Access Compliance Report Public Rights-of-Way (Curb Ramps)

Main Street: REATA_RD Cross Street: N/A Location: NE

ADA ID: RPRK211118134049 Ramp Type: Type 1 - Perpendicular Initial Pass/Fail: Pass Overall Compliance: No Severity Score: 0

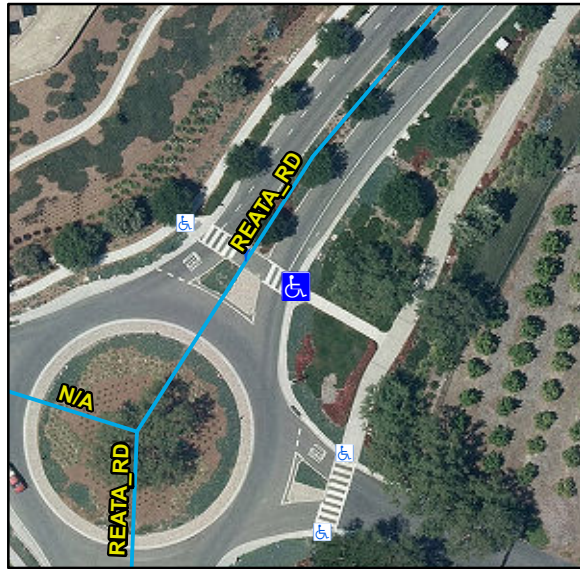
Possible Solutions:

Remove & Replace Curb Slope.

R304.2.2, STD 1115
